**ADDENDUM 2****Addendum #** 2**Date Issued** January 27, 2026**Project Name | Job #** White Earth Withdrawal Management Facility | 20237410**Bid Date | Time** Tuesday, February 3, 2026 | 3:00 pm

THIS ADDENDUM AMENDS AND BECOMES PART OF THE CONTRACT DOCUMENTS FOR EAPC PROJECT 20245580 DATED 12/5/2025, RESPECTIVELY. EACH BIDDER SHALL ACKNOWLEDGE RECEIPT OF THIS ADDENDUM BY MARKING THE ADDENDUM NUMBER AND DATE ON THE BID FORM.

1
E401

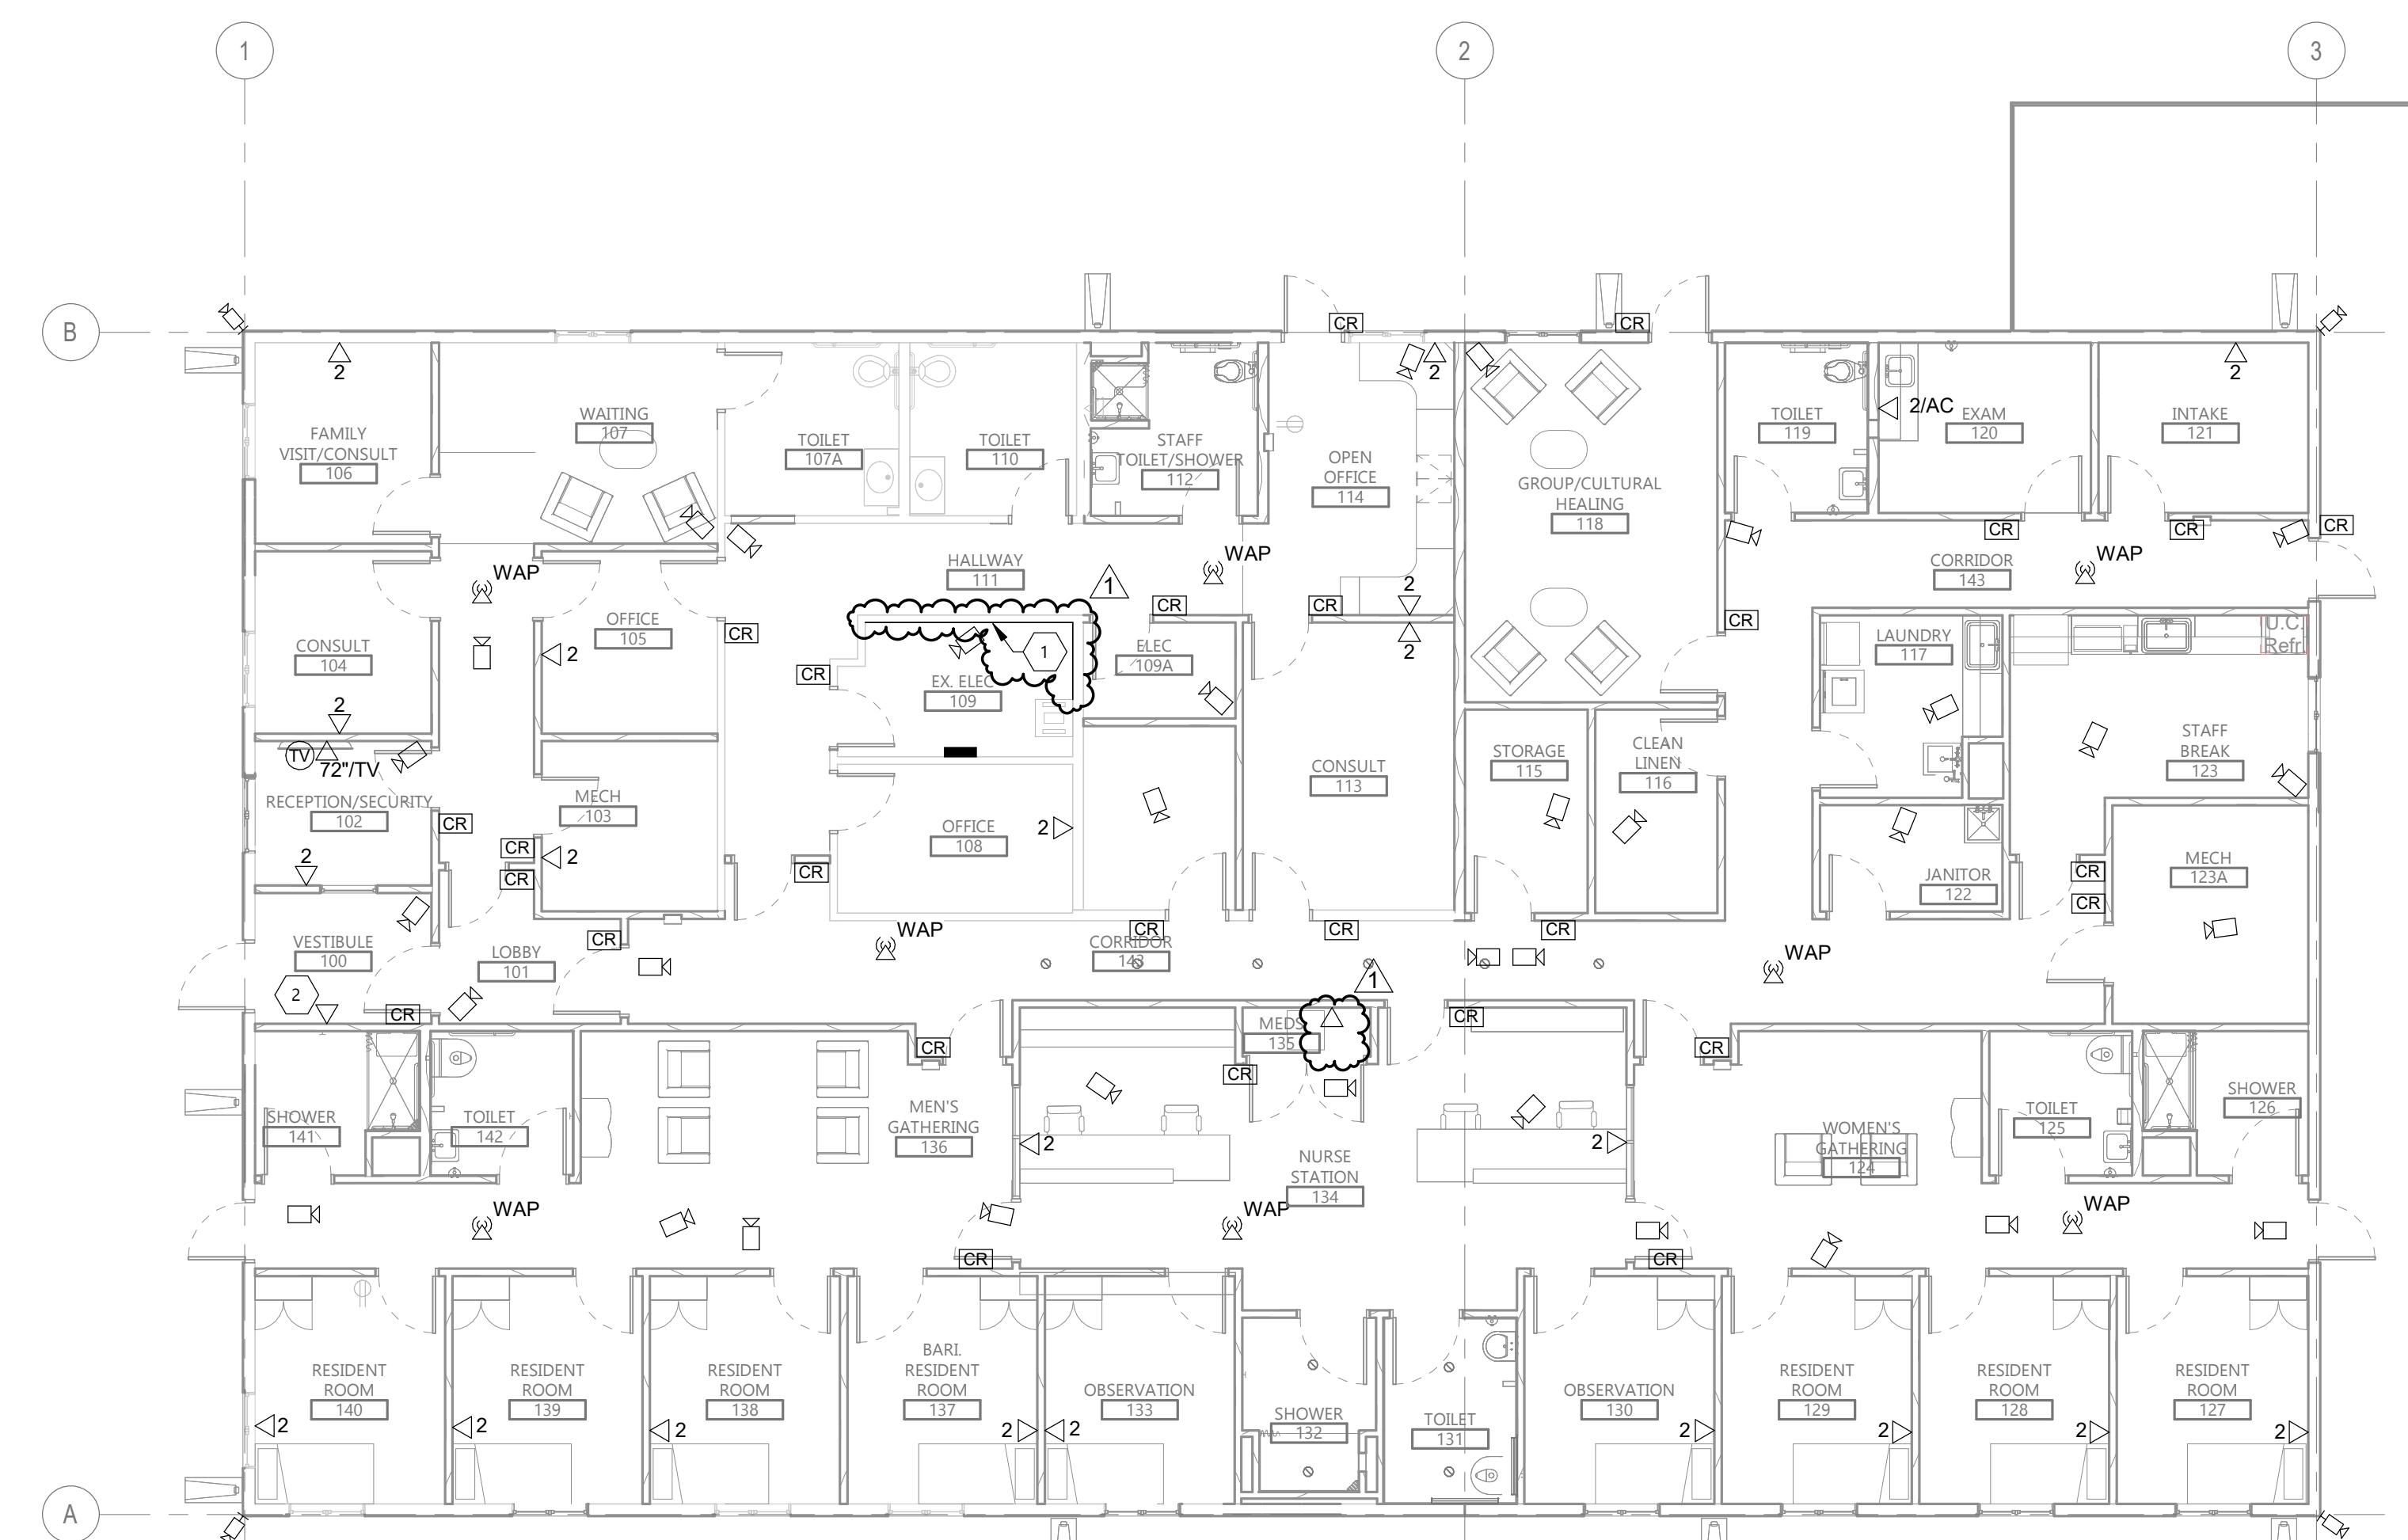
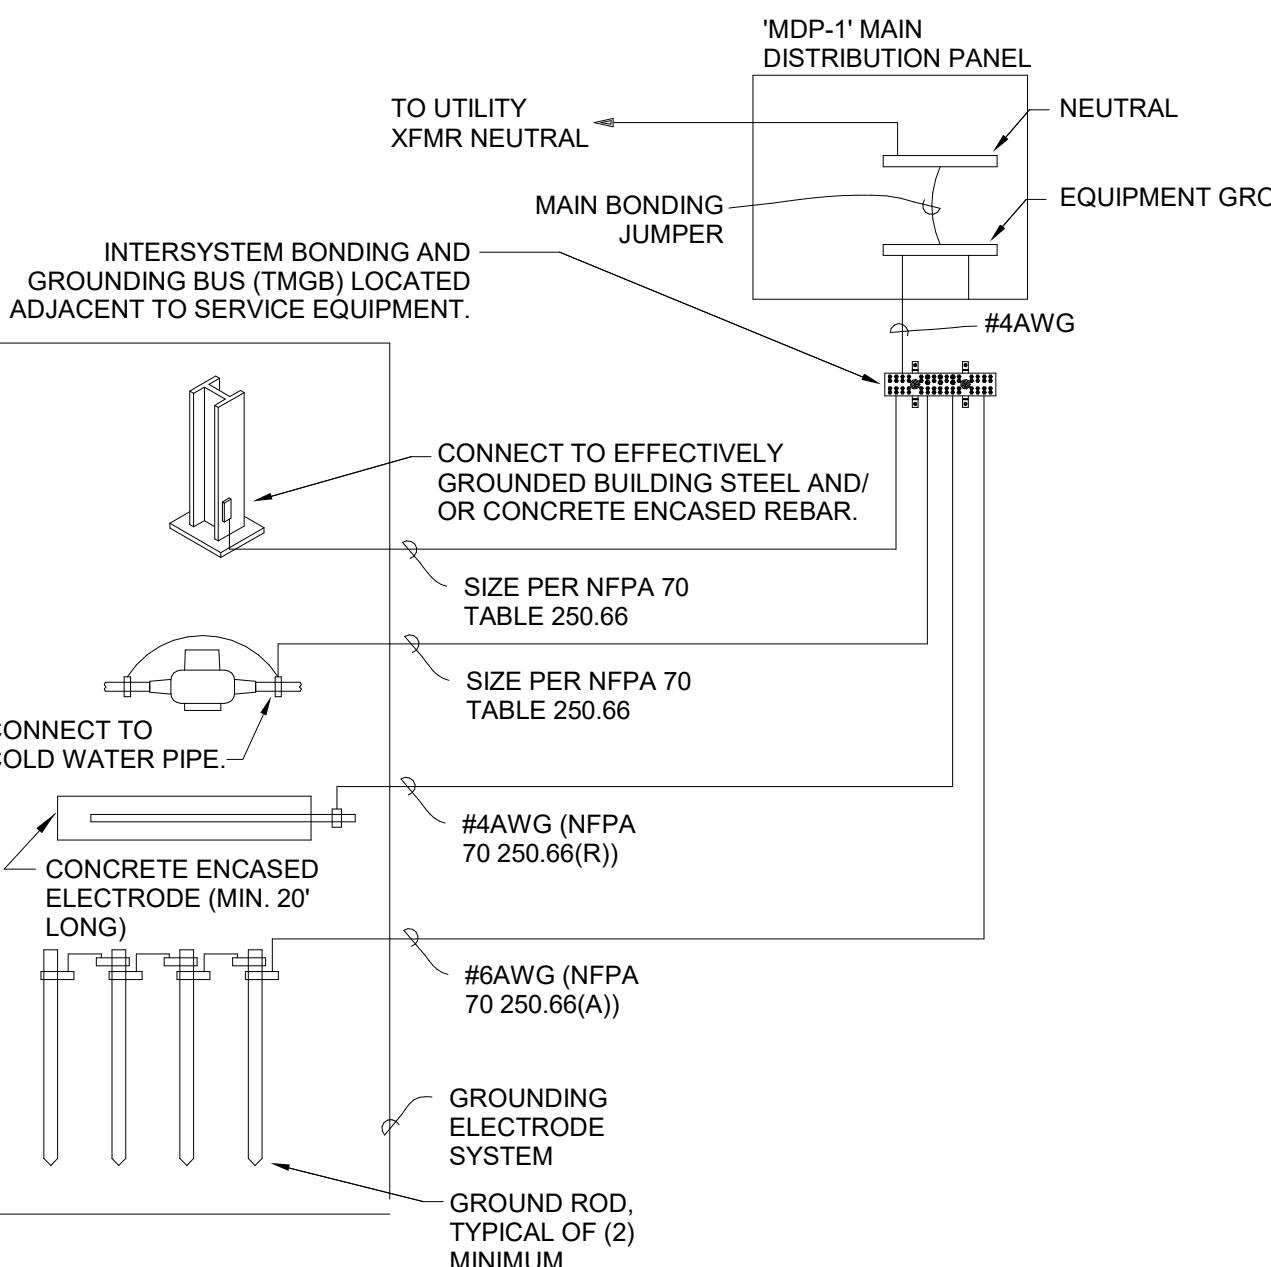
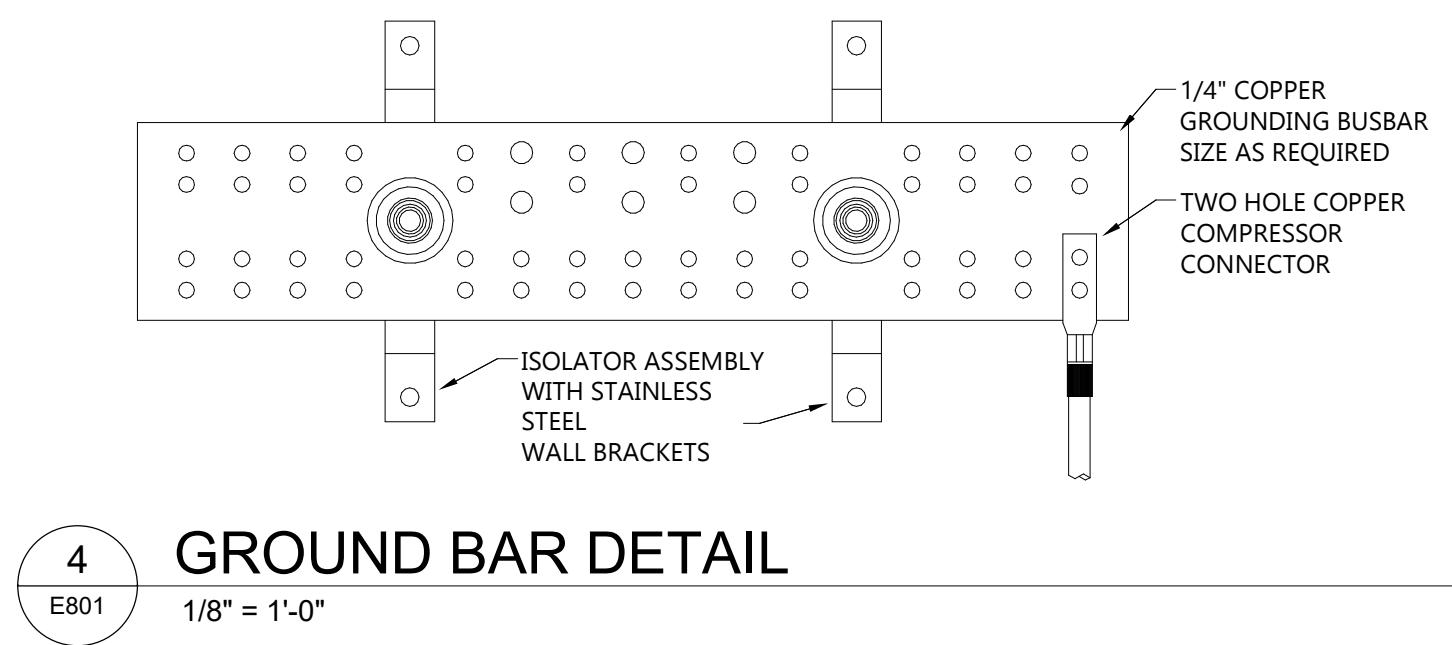
E401 ADDED General Note F.

ADDED Keynote 1 to Room 109.

E801

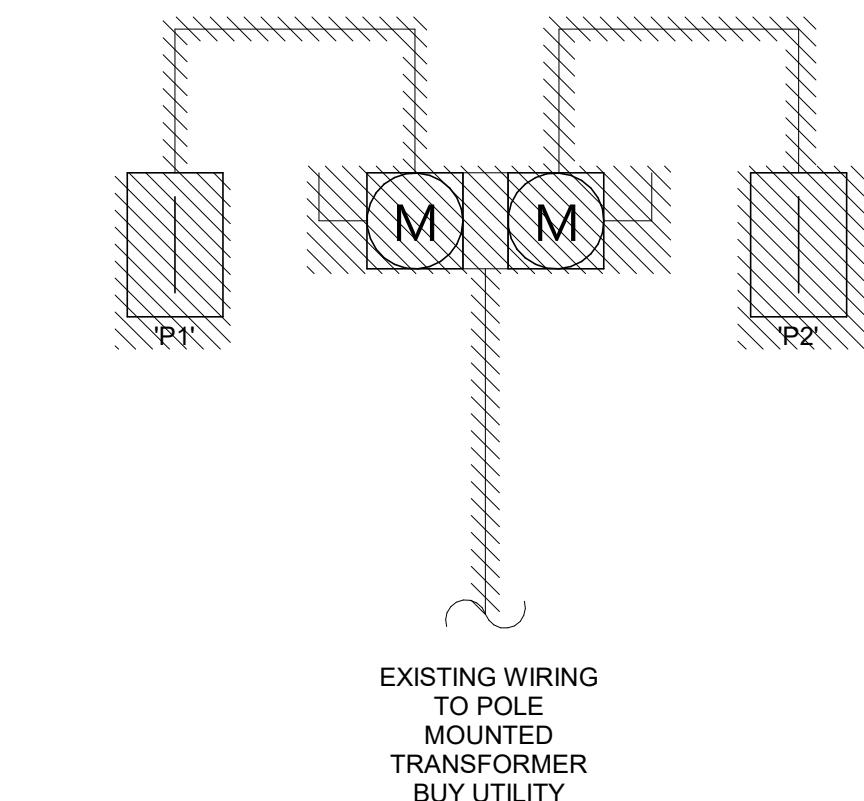
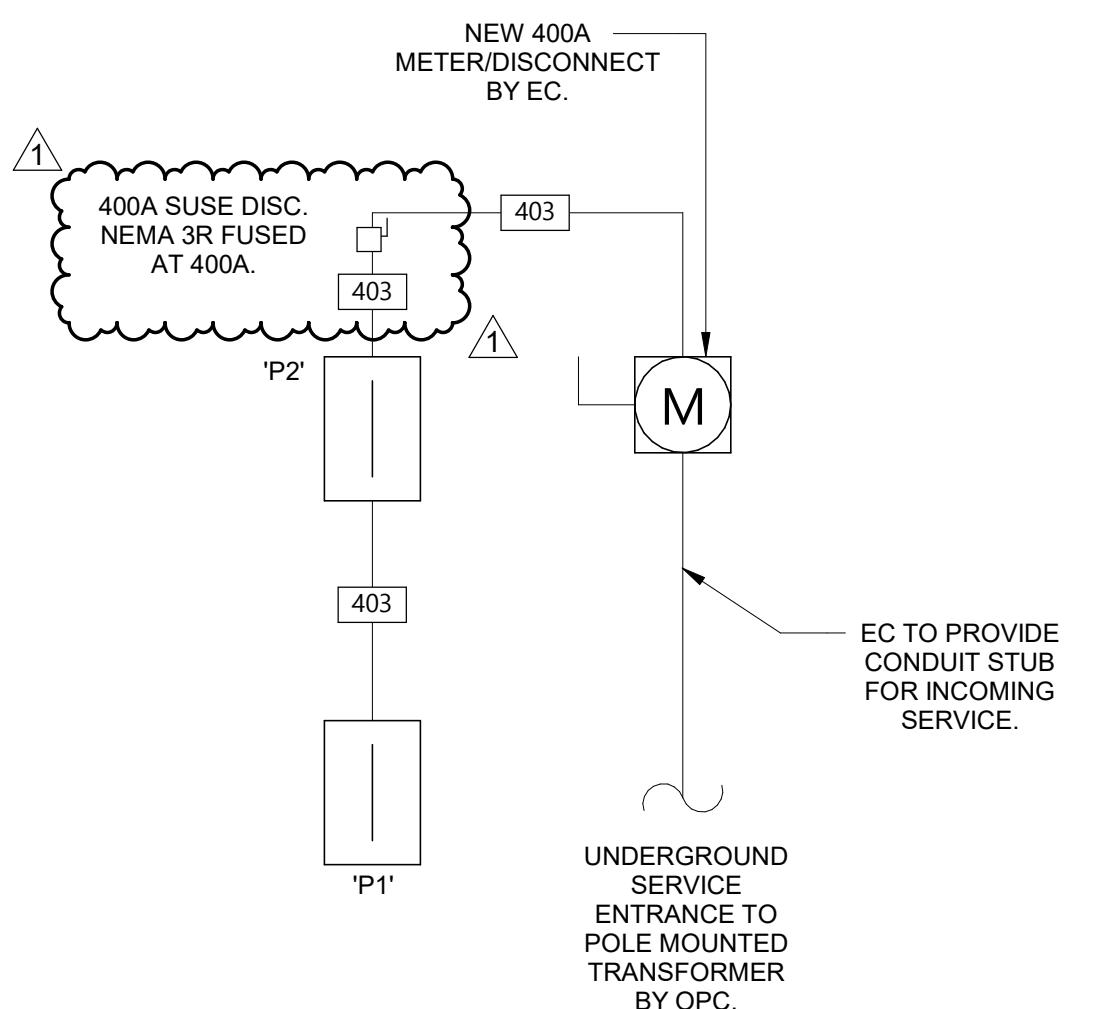
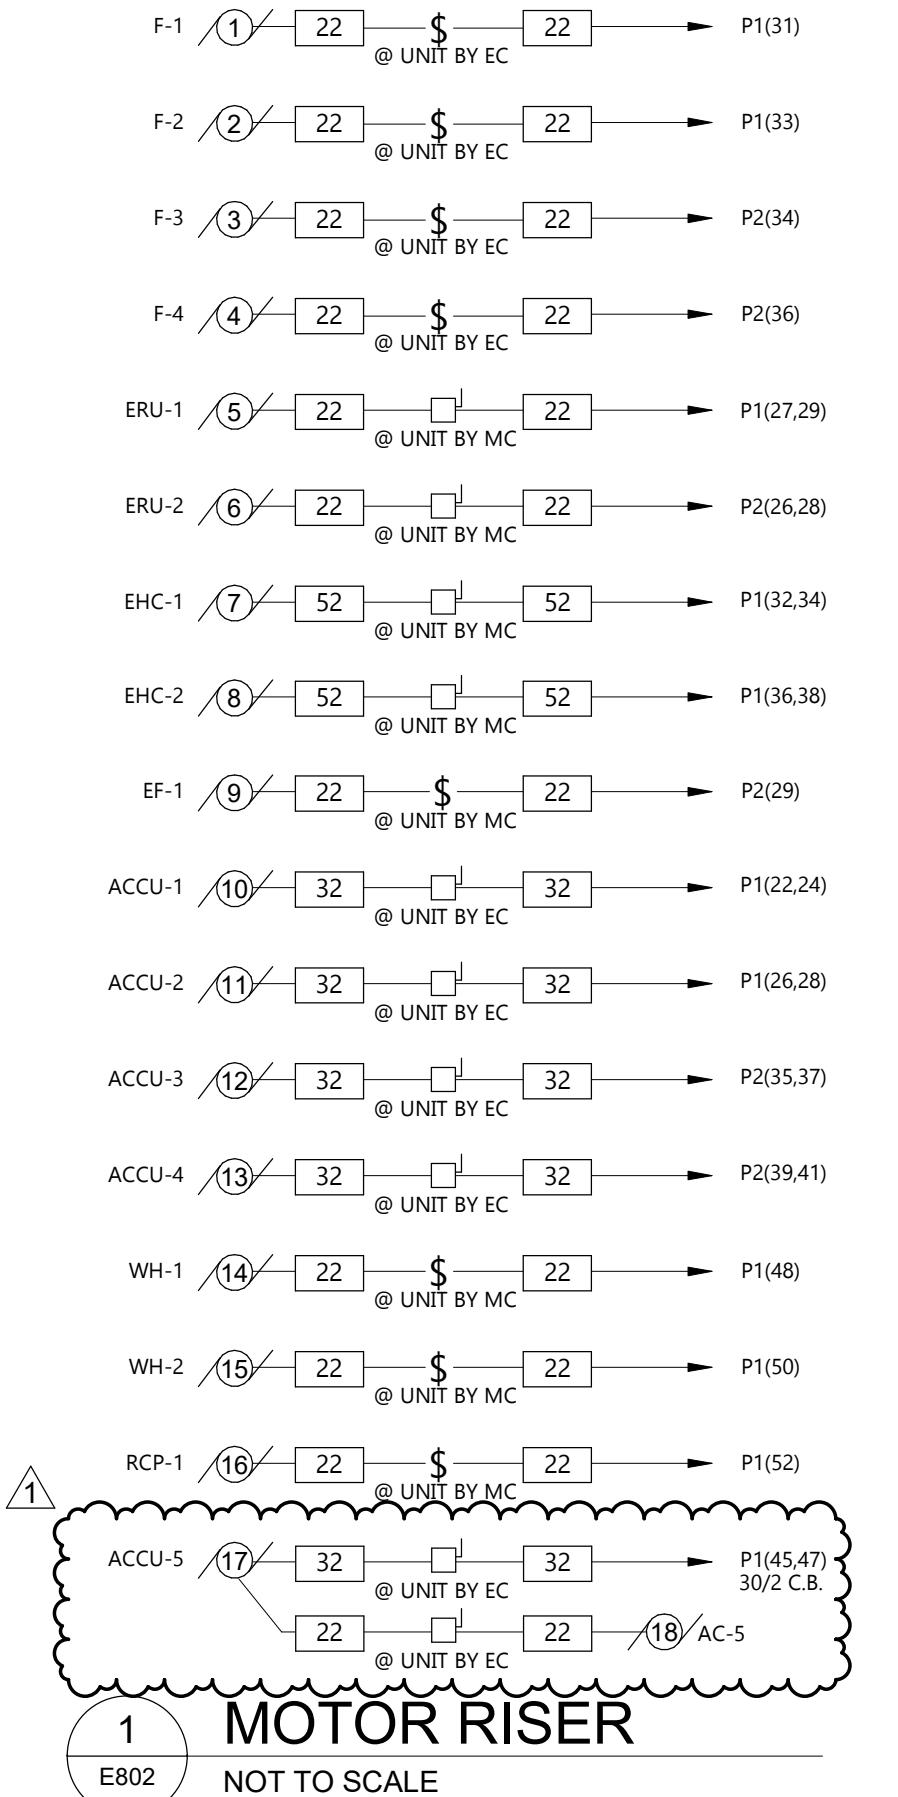
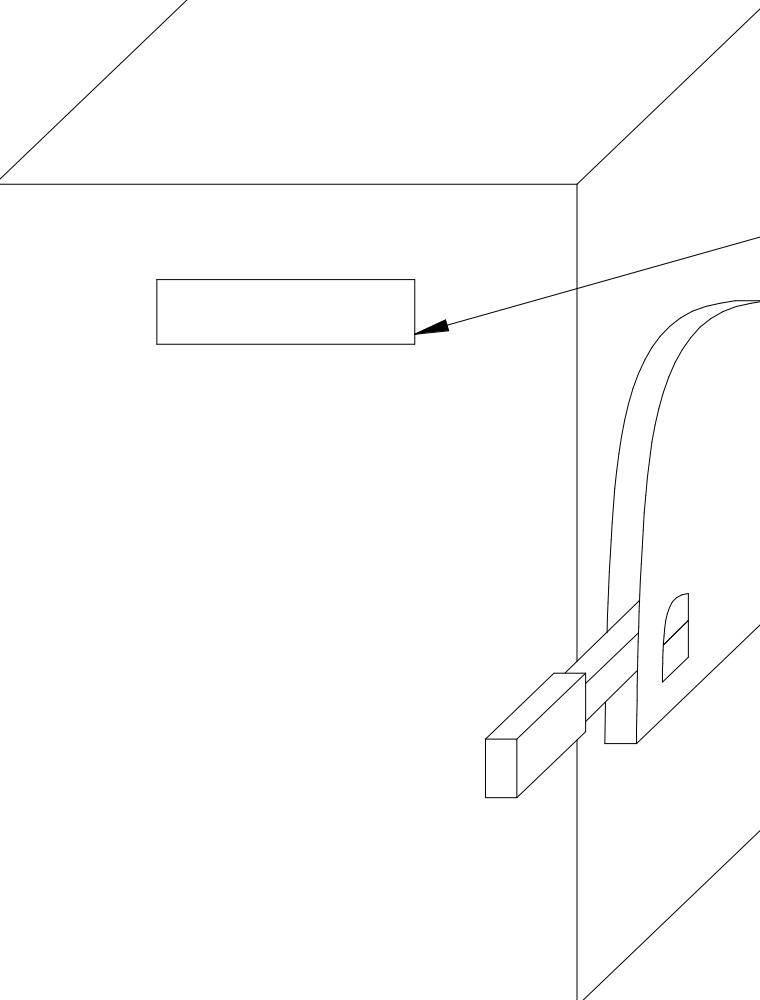
E801 REVISED Meter demolition on Existing One-line Diagram.

ADDED Disconnect to Revised One-line Diagram.
